Access Compliance Report Public Rights-of-Way (Curb Ramps)

Main Street: IRVINE_AVE Cross Street: UNIVERSITY_DR Location: SE

ADA ID: RPRK211018114559 Ramp Type: Type 4 - Parallel Initial Pass/Fail: Fail Overall Compliance: No Severity Score: 15

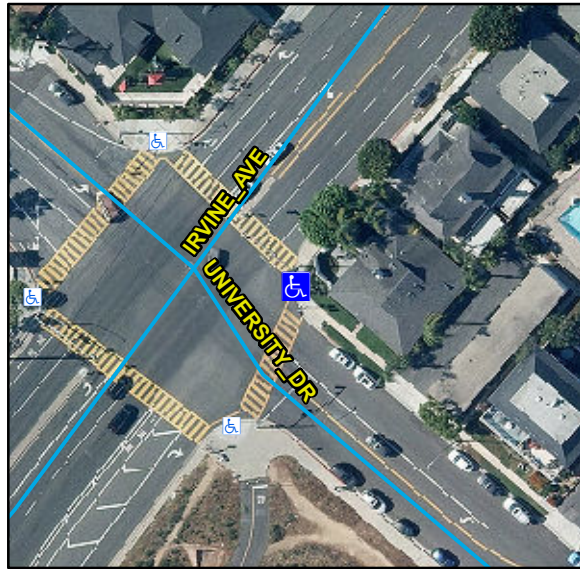
Compliance	Description	Data	Compliance	Description	Data
N/A	Ramp Length LT (in)	94	N/A	Ramp Length RT (in)	80
Yes	Ramp Width LT (in)	48	Yes	Ramp Width RT (in)	57
No	Ramp Run Slope LT (%)	8.5	Yes	Ramp Run Slope RT (%)	6.8
Yes	Ramp Cross Slope LT (%)	1.6	Yes	Ramp Cross Slope RT (%)	0.7
N/A	Landing Present	N/A	N/A	DWS Provided	N/A
N/A	Landing Length (in)	N/A	N/A	DWS Contrast	N/A
N/A	Landing Width (in)	N/A	N/A	DWS Length (in)	N/A
N/A	Landing Run Slope (%)	N/A	N/A	DWS Full Width	N/A
N/A	Landing Cross Slope (%)	N/A		DWS Offset Type	N/A
N/A	Landing Movement Obstructed?	N/A	N/A	DWS Offset Left (in)	N/A
	Landing Movement Type	N/A	N/A	DWS Offset Right (in)	N/A
N/A	Landing Shared	N/A			
N/A	Clear Space	Yes			
N/A	Clear Space To Crosswalk (in)	48			
N/A	Marked Crosswalk 1	Yes	N/A	Marked Crosswalk 2	Yes
	Crossing 1 Direction	NW		Crossing 2 Direction	SW
	Marked Crosswalk 1 Width (in)	144		Marked Crosswalk 2 Width (in)	144

Remove & Replace Curb Ramp With Two New Directional Ramps or Equivalent.
